REMARKS

DOCKET NO.: HITACHI-0012
Serial No.: 09/650,506
Amdt. dated April 27, 2004
Response to Office Action of October 27, 2003
Annotated Version

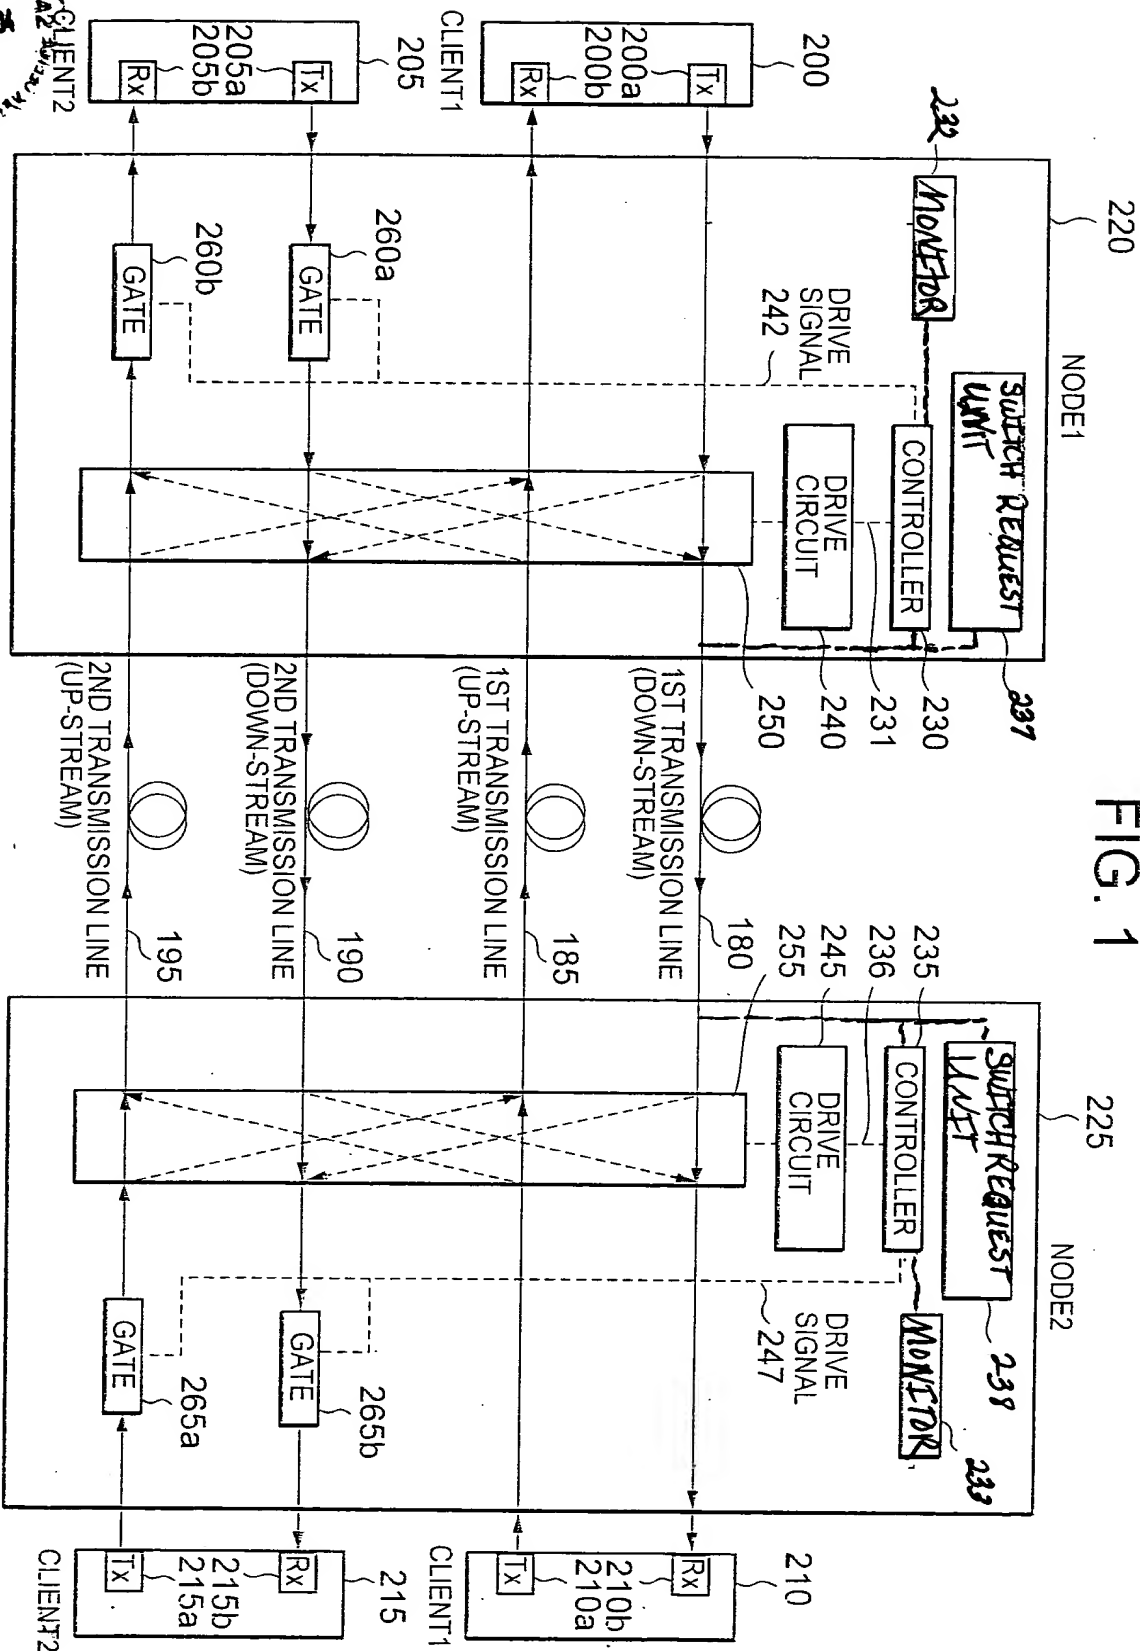
With respect to claims 19 and 32, to clarify the support for the subject matter limitations, FIGURE 1 has been amended to include the monitor 232, 233 and the switch request unit 237, 238. These elements have been supported by the original disclosures at lines 21 and 25 on page 6 of the current application. In this regard, the reference numerals of these originally supported elements are also incorporated in the specification on page 6. For the above reasons, the Applicants respectfully submit to the Examiner that the additional claim and drawing amendments should be entered.

(PRIOR ART) FIG. 12A

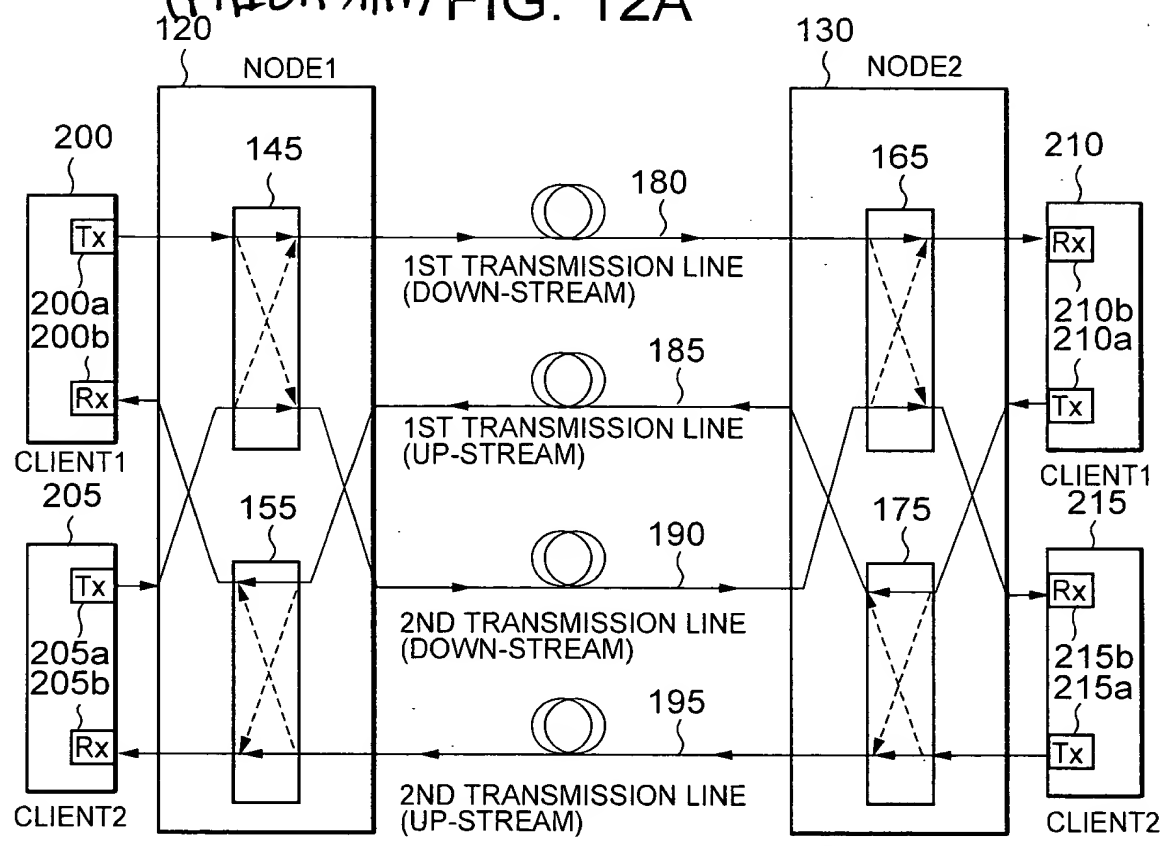
The Examiner has objected to FIGURES 12A, 12B and 13 for the lack of a prior art legend. Accordingly, the Applicants corrected the drawings to incorporate a prior art label as the Examiner has kindly suggested. Thus, the Applicants respectfully submit to the Examiner that that the drawing objections should be withdrawn.
